West Winder Bypass
CSSTP-0006-00(327), P.I. No. 0006327
Barrow County

Value Engineering Study Report

April 2010

ALTERNATIVE NO.: **13**

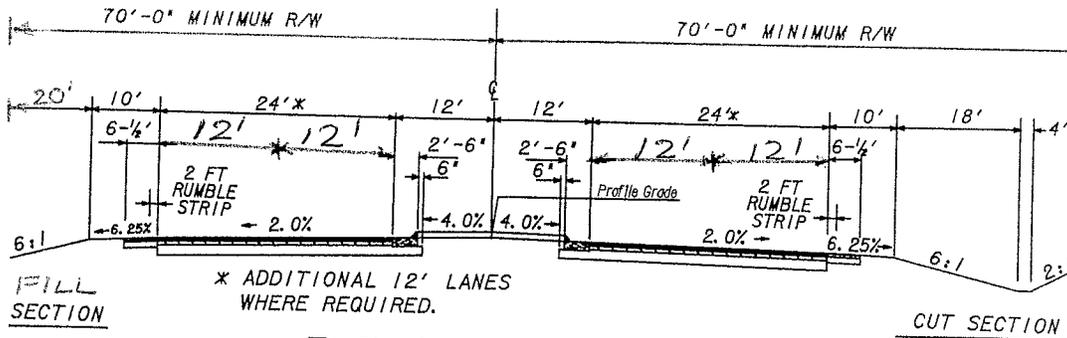
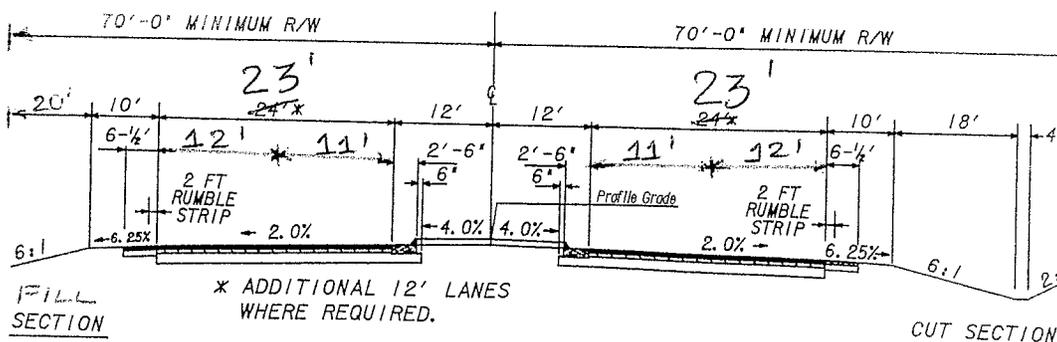
With 55 mph speed limit, 11-ft.-wide lanes have existed on I-75 and I-85 in Metro Atlanta since 1996. The speed limit on the West Winder Bypass is 45 mph. Since the inside lanes will have two feet of gutter, the effective travel width with 11-ft.-wide lanes will be 13 feet. A foot of reduction on each side will decrease impervious area. This will reduce storm water. As a result, the amount of drainage infrastructure will also decrease. Since drainage design has not been completed, no savings in drainage items are included with the alternative design. Also, no savings in right-of-way is included because it is assumed that the same amount of right-of-way would still be acquired even though one foot less width will be required on each side. However, if combined with Alt. No. 17 which narrows the median 4 ft., then the total right-of-way could be reduced by 10 ft.

ALT. 14
PAGE 2 of 4

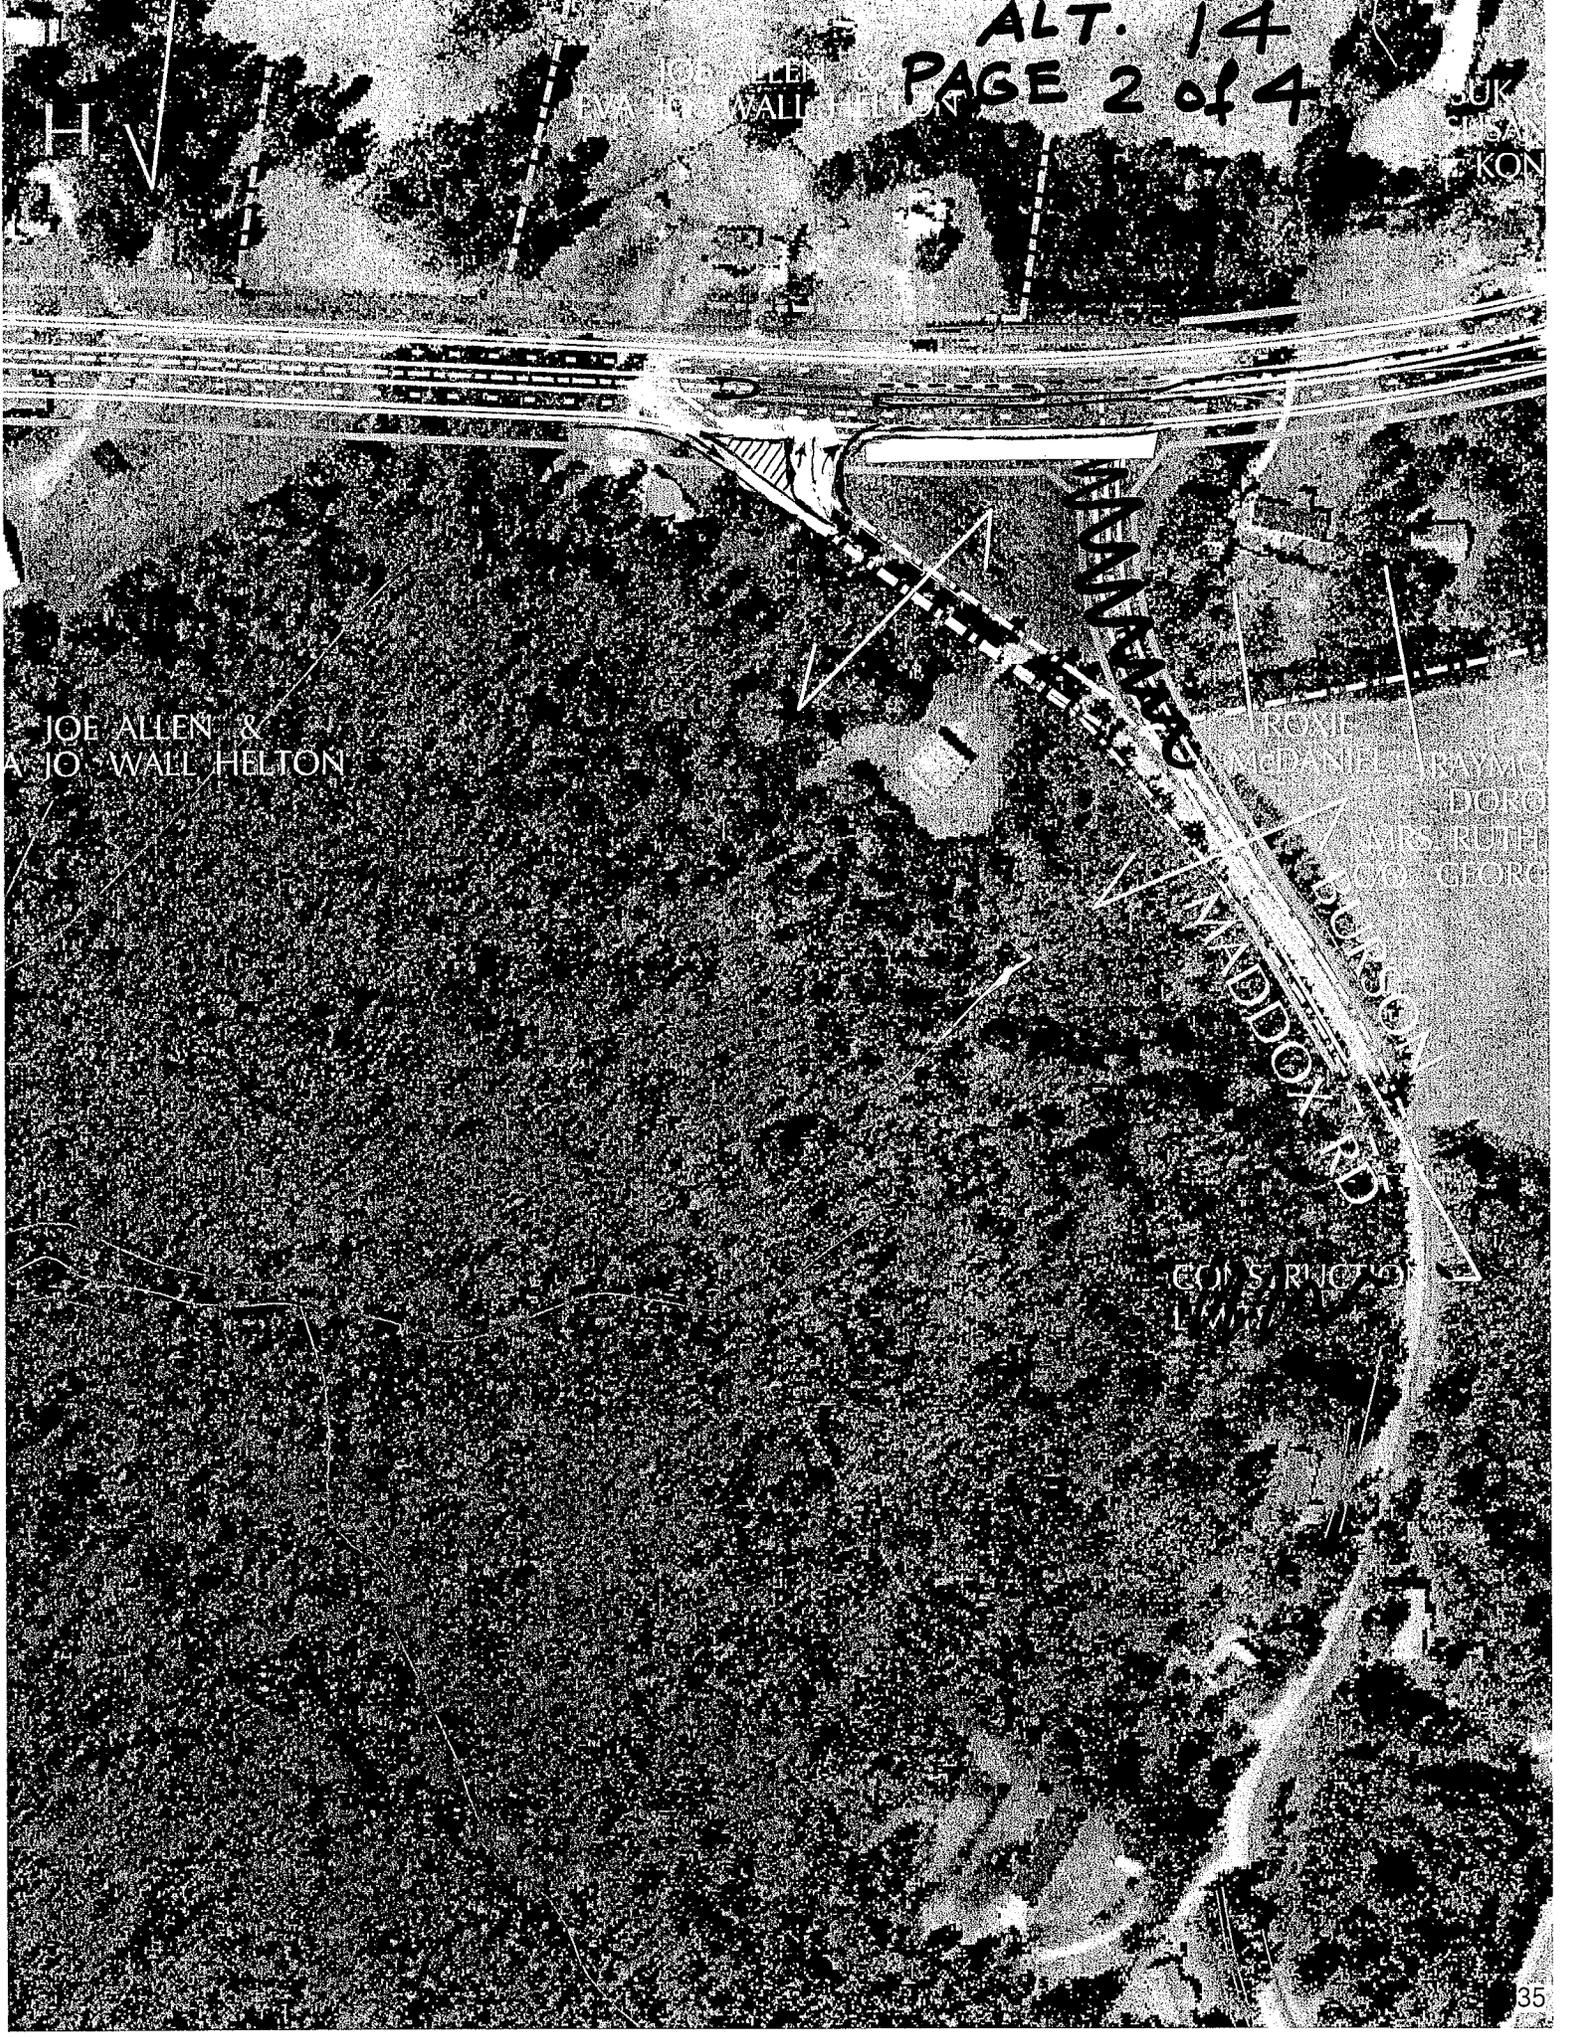
The alternate design recommends maintaining the alignment of Burson Maddox Road in its current position until it almost intersects with the West Winder Bypass. As a result, the existing access from the current homeowner's property to Burson Maddox Road will not change and it will not be necessary to acquire a large triangular tract of land from Roxie McDaniel on the north side of the existing road.
